Addendum #1 - Bid Package #6929-08

Project Name: Lincoln Public Schools District Office
5901 'O' Street
Lincoln, NE
Project No.: 11065
Issued: September 18, 2012

Sketch A2
 Bid Package 6929-08
 Addendum 01
 Revised Detail A7/A601

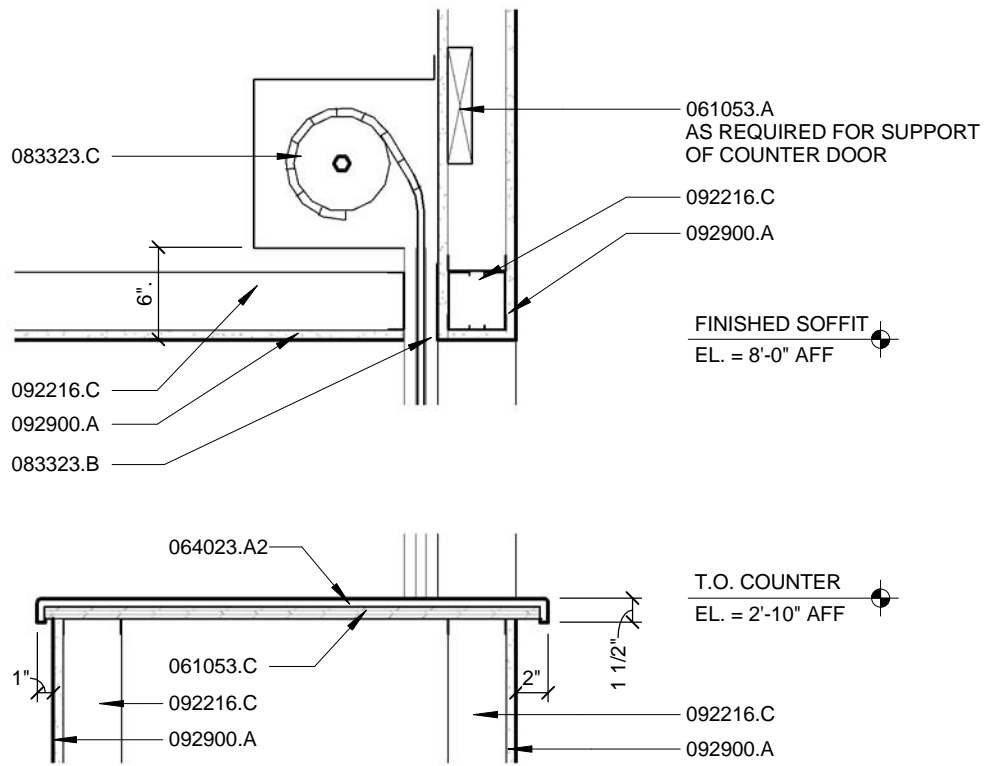
1. Change keynote 064023.B to 064023.A2
 2. Add keynote 064023.A6
- ADD 1-48.** Refer to Sheet A601, Detail A7; Wood paneling has been added to the conference room side of the wall assembly. Refer to attached **Sketch A2** for revisions.

COUNTER DOOR AND COUNTER DETAIL AT KITCHENETTE 101B

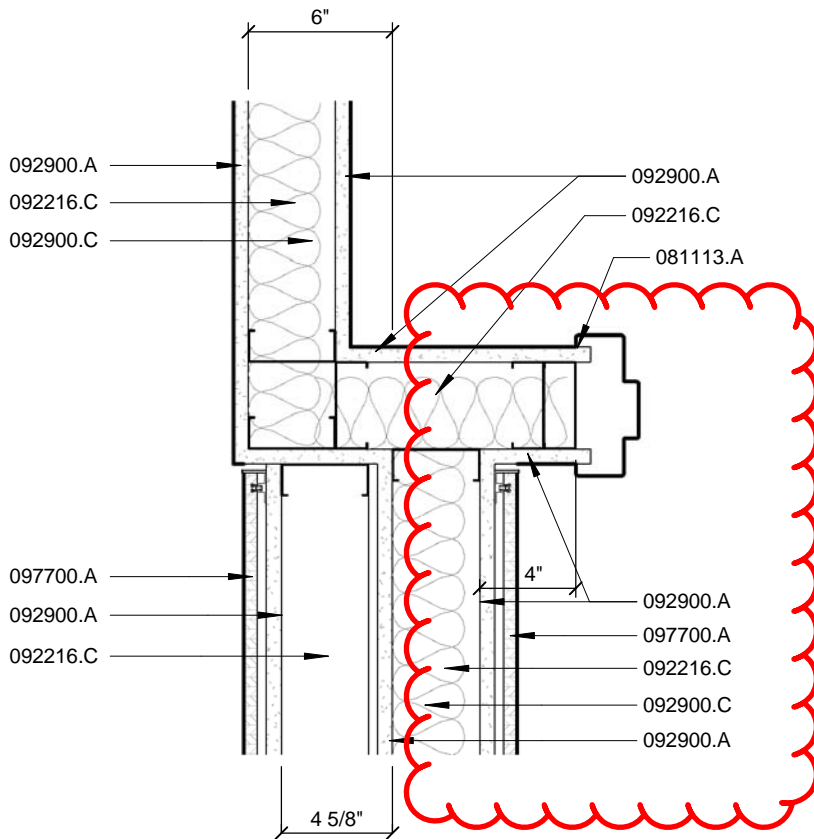
- ADD 1-49.** Refer to Sheet A601; Add Detail D1 as shown on the attached **Sketch A3**.
- ADD 1-50.** Refer to Sheet A601, Detail D7; Wood paneling has been added to the conference room side of the wall assembly. Refer to attached **Sketch A4** for revisions.

Sketch A5
 Bid Package 6929-08
 Addendum 01
 Modification to Detail A1/A102

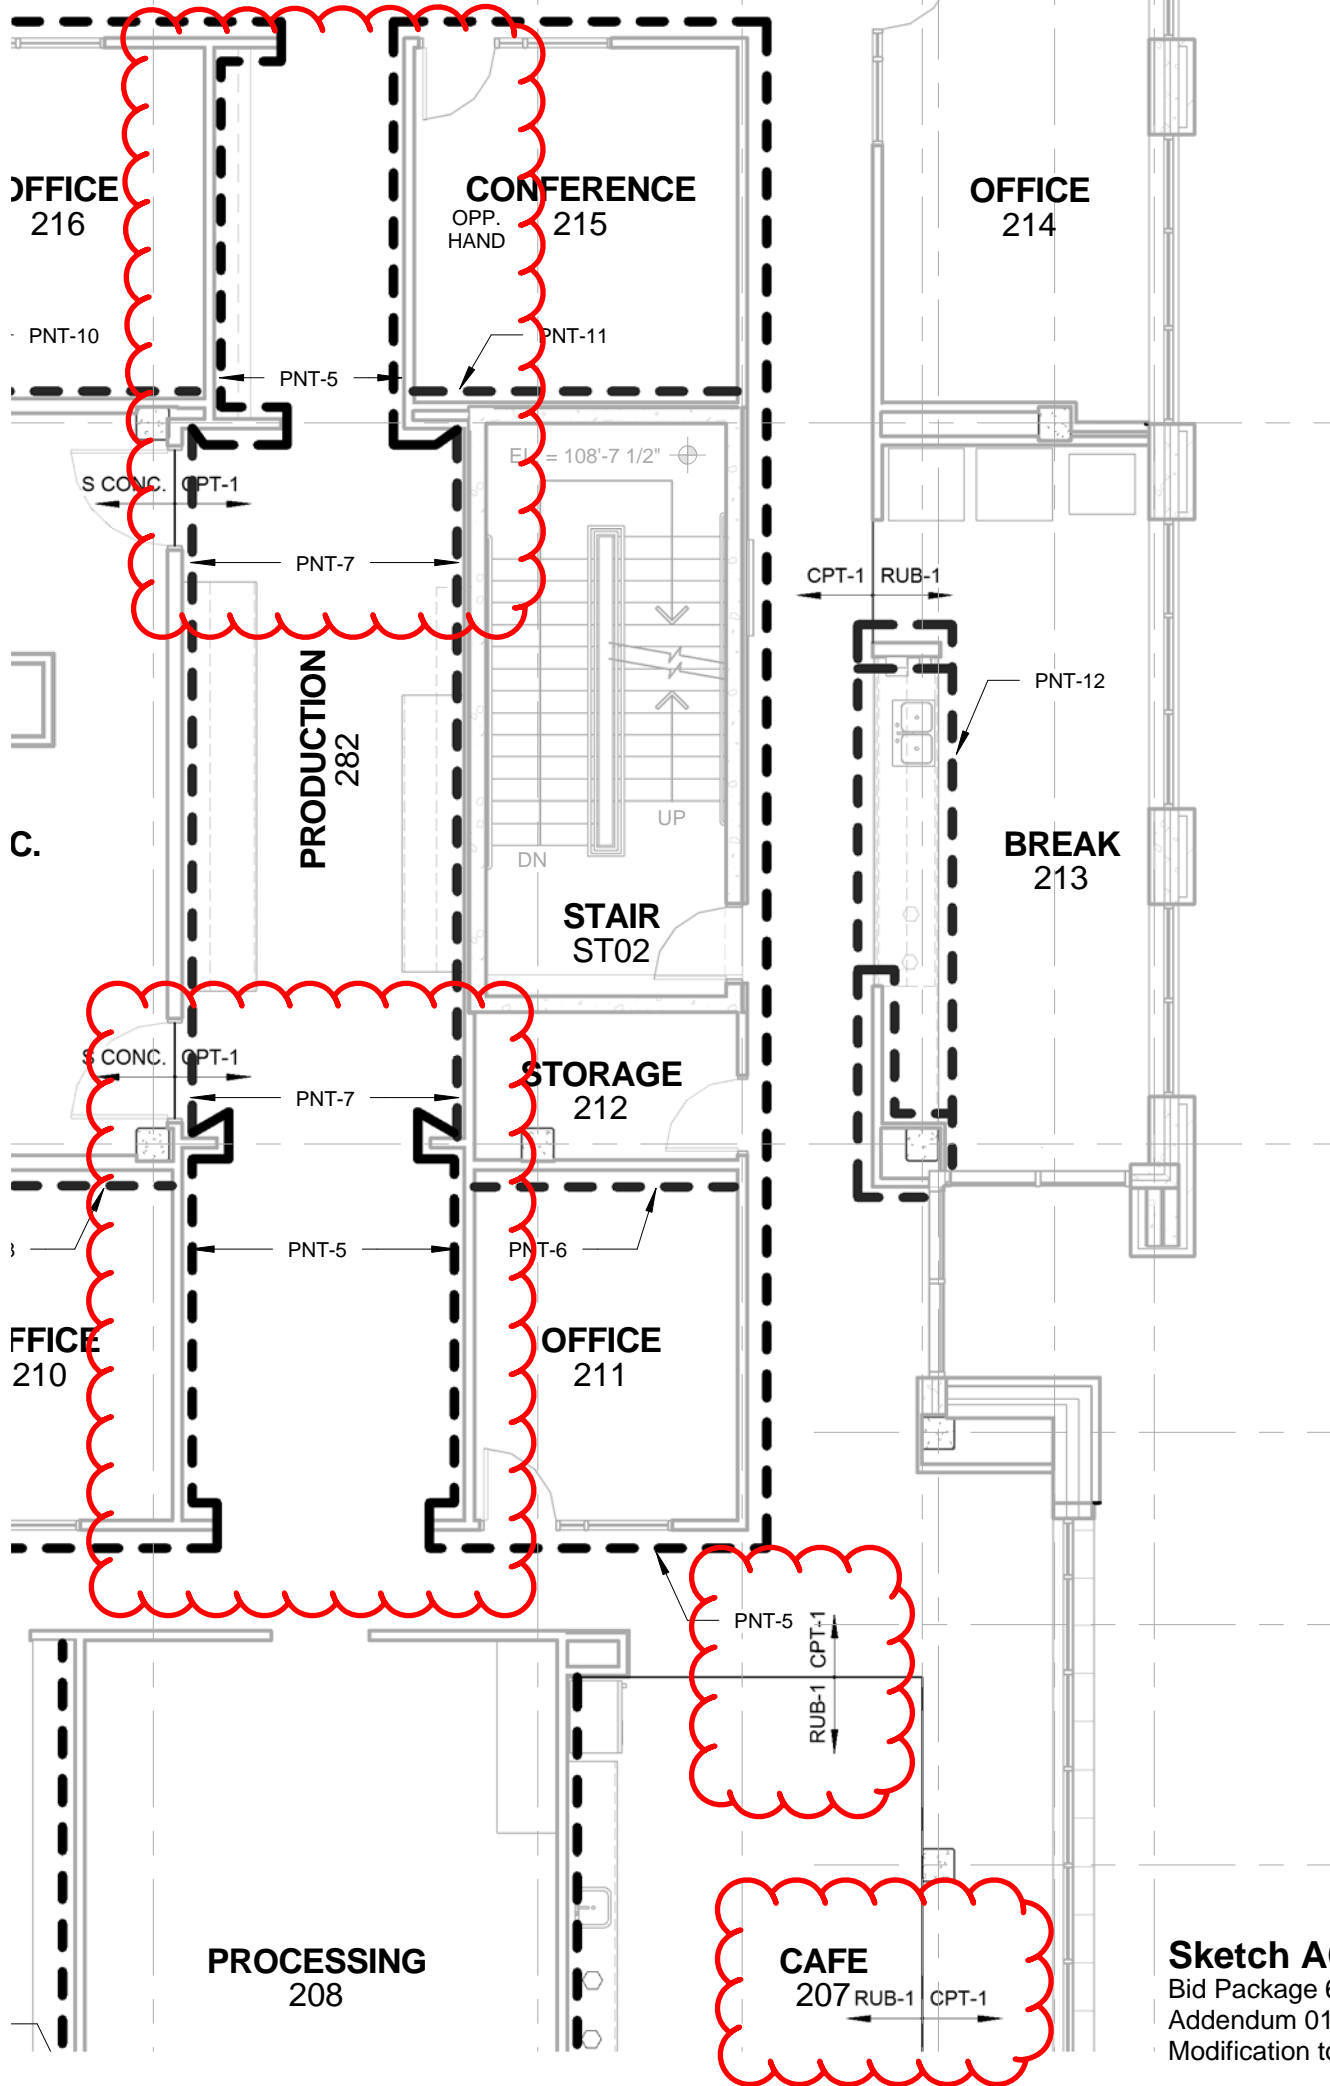
- ADD 1-34.** Refer to Sheet A102; Add callout for Note 6 as shown on attached **Sketch A5** and add Sheet Note 6 to Sheet A102 Sheet Specific Notes as follows:

- NOTE 6 TERMINATION OF WOOD WALL PANEL SYSTEM
- ADD 1-35.** Refer to Sheet A102; Eliminate reference to Corridors C17 and C19 found south of Grid 3 between Grids B and C. These “rooms” no longer exist and this area is to be considered part of Break 234 as is the case on other Levels.

Sketch A6
 Bid Package 6929-08
 Addendum 01
 Modification to A1/A802

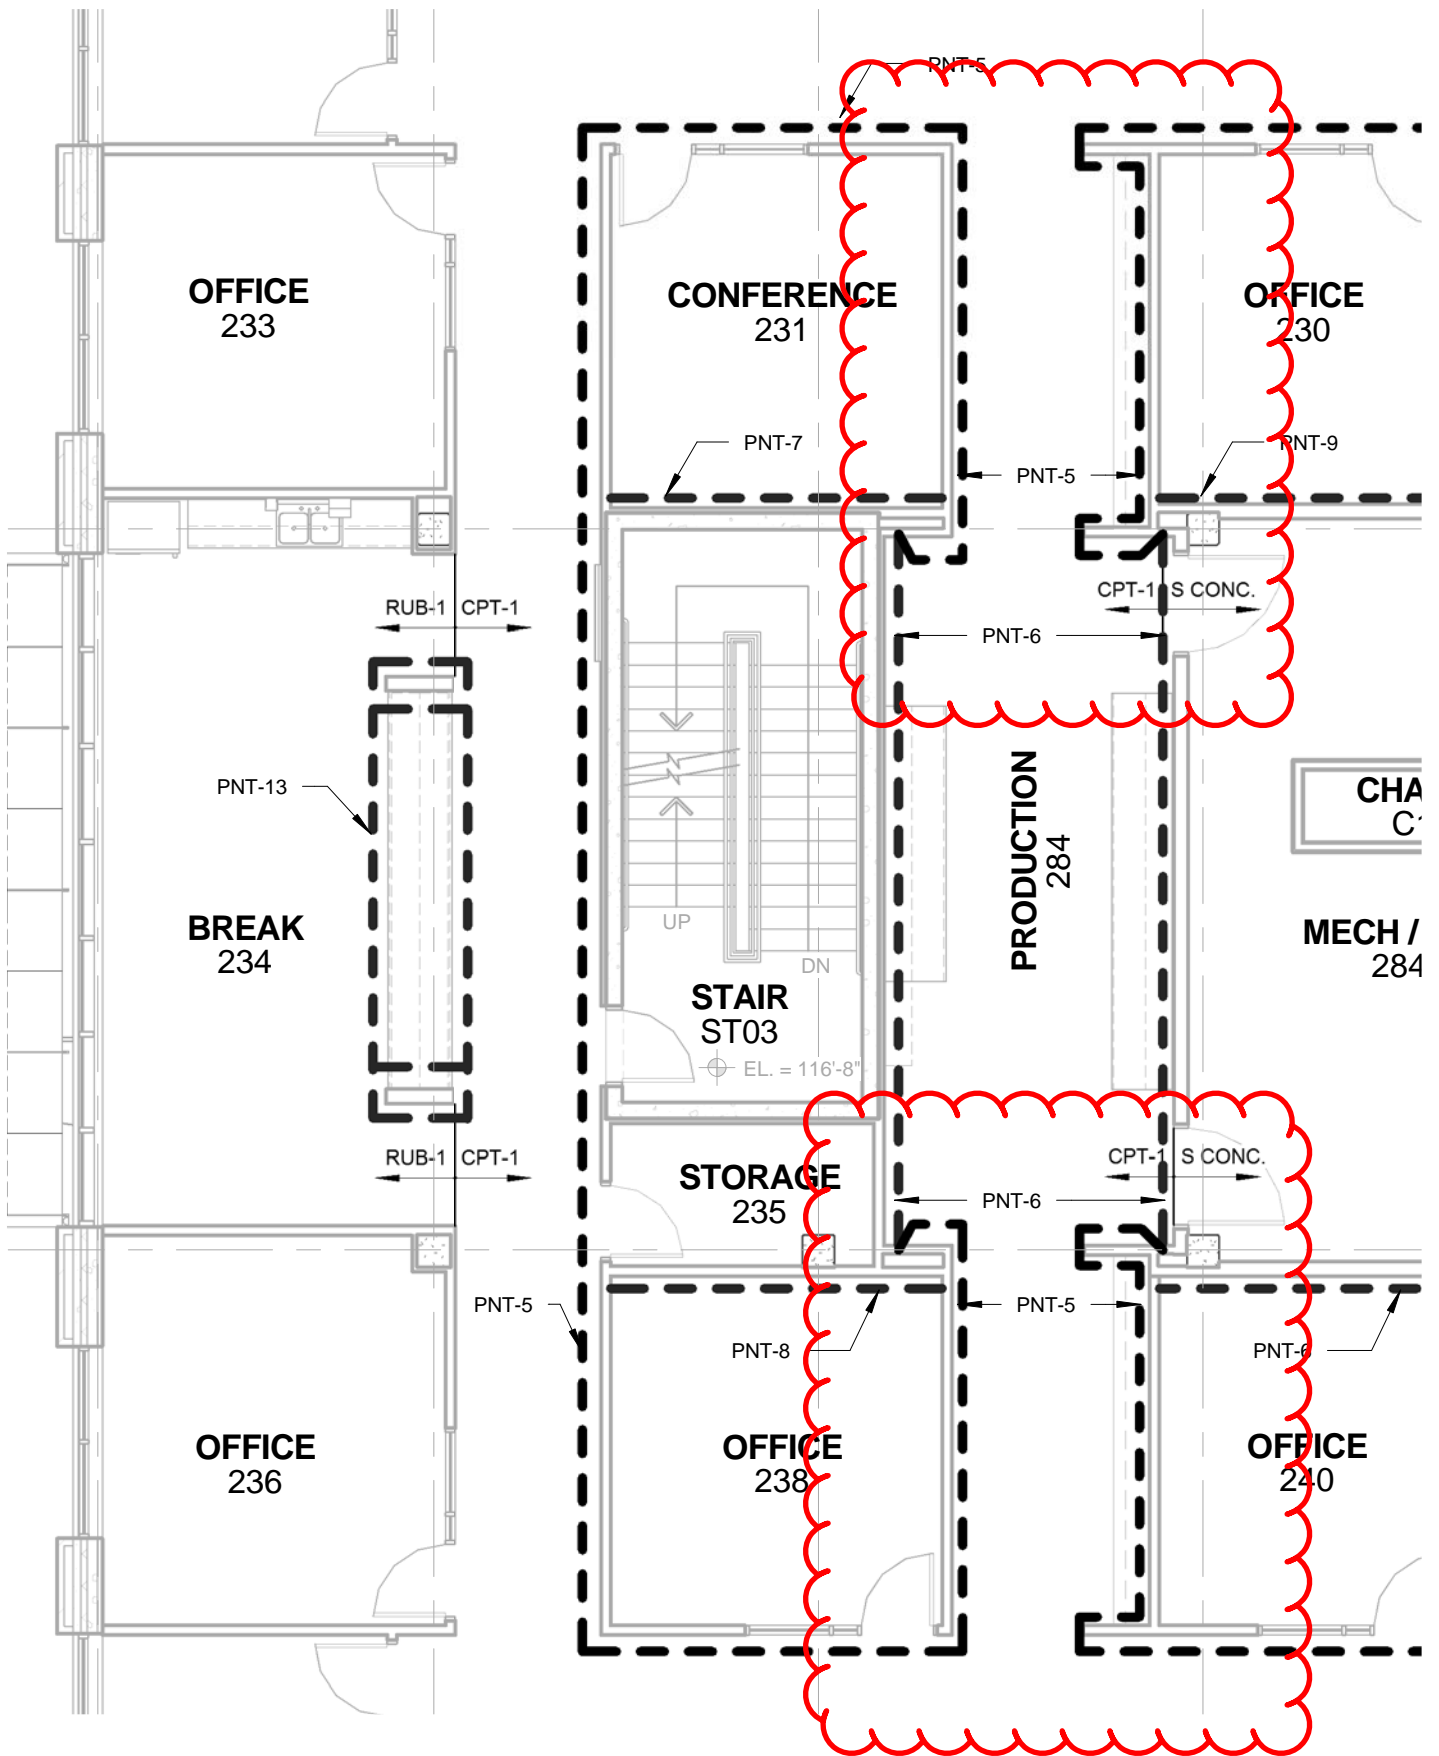
- ADD 1-58.** Refer to Sheet A802, Floor Transition Annotations at entry to Men 281B and Women 281G; The CT-1 should be changed to CT-4.
- ADD 1-59.** Refer to Sheet A802, Café 207; The north and west floor transition callouts have the CPT-2 and RUB-1 annotations on the wrong side. Refer to attached **Sketch A6** for modifications.

Sketch A7
 Bid Package 6929-08
 Addendum 01
 Modification to A1/A802

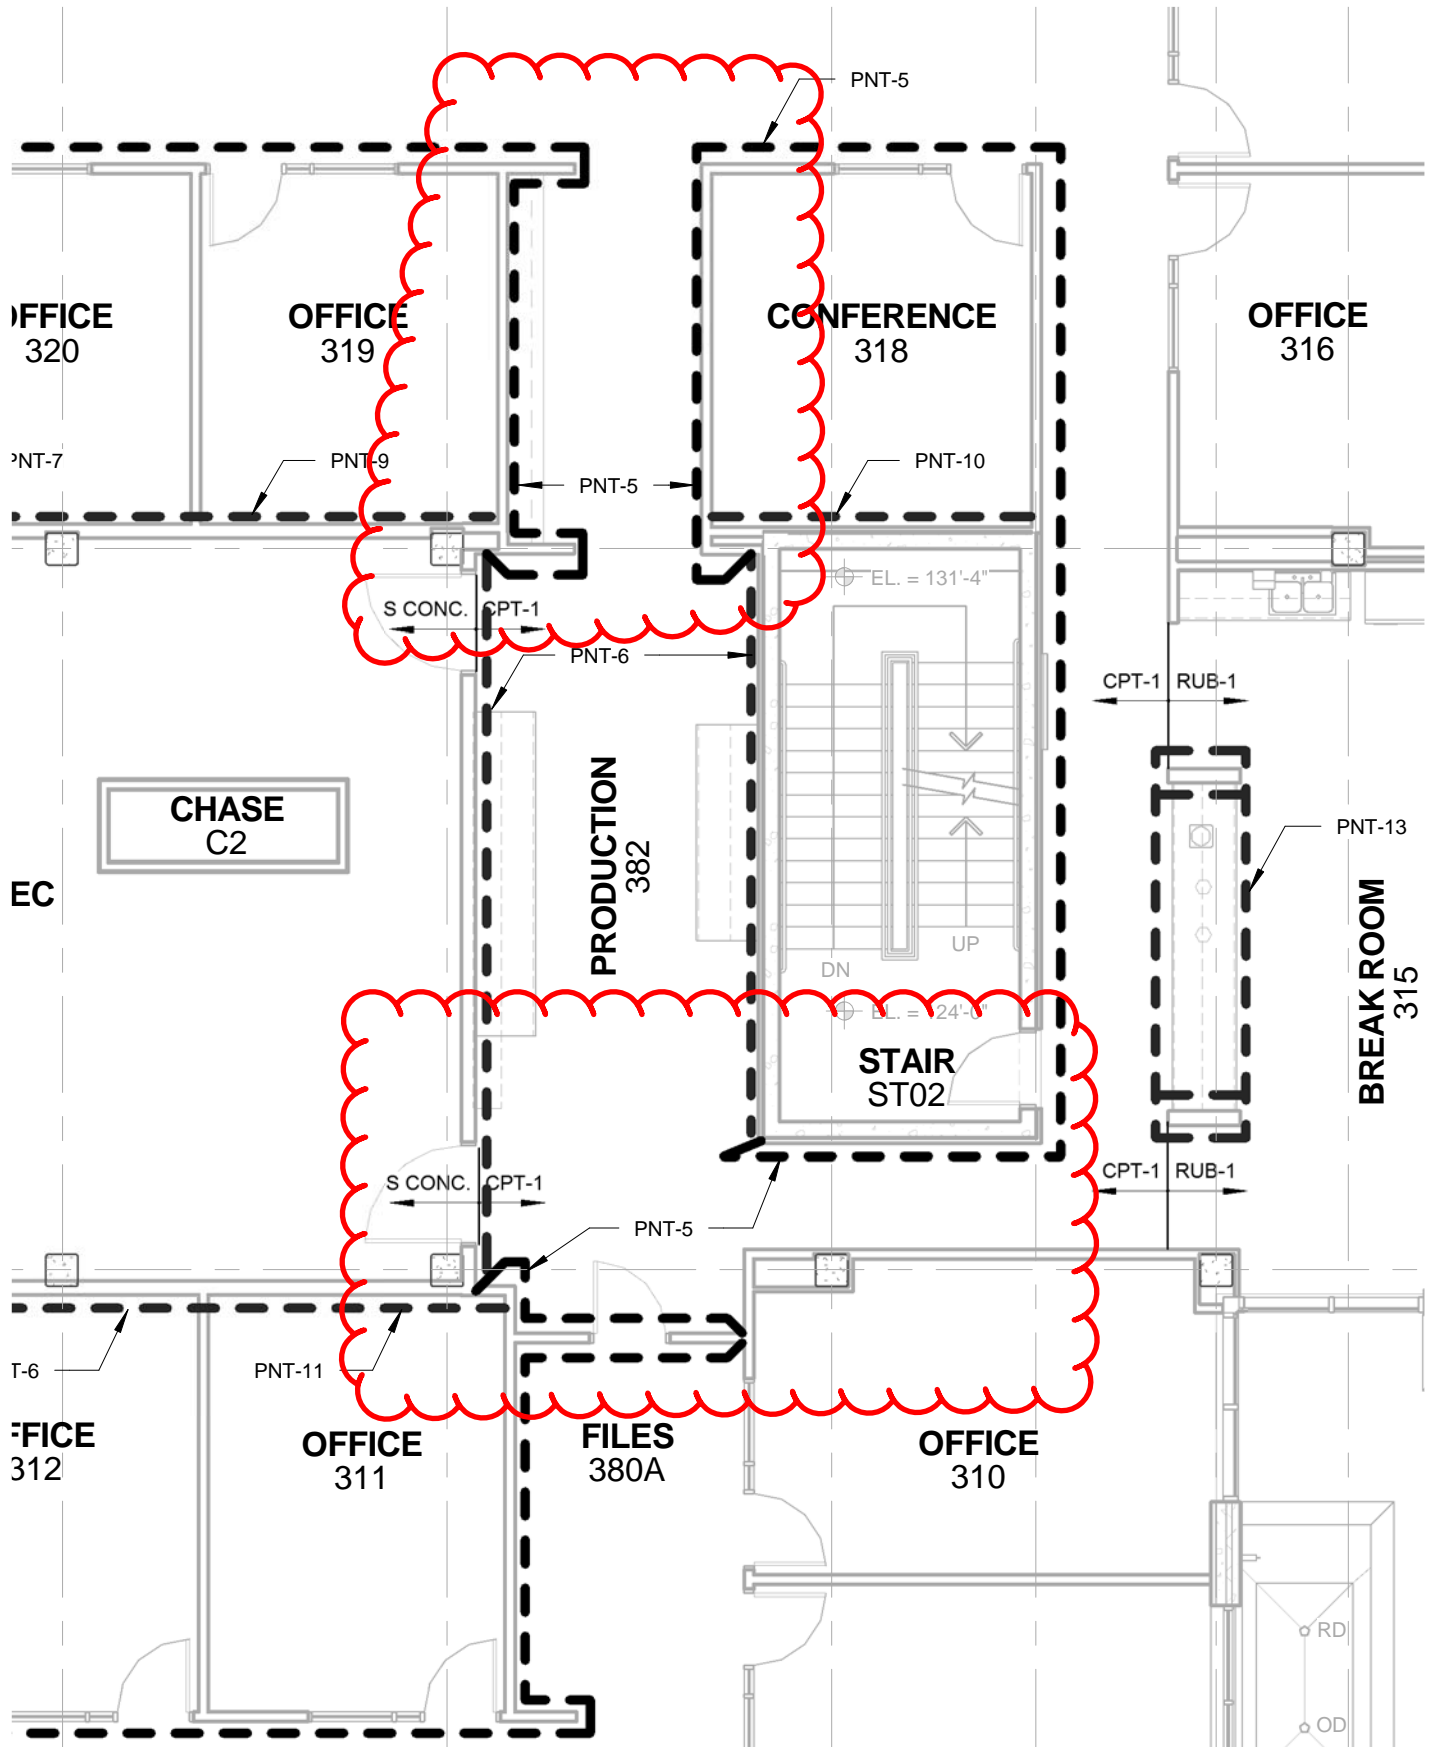
- ADD 1-61.** Refer to Sheet A802, Production 284; The paint color transition lines have been modified at the corridor niches west of Grid B and east of Grid C to reflect what has been indicated in the Room Finish Schedules. Refer to attached **Sketch A7**.
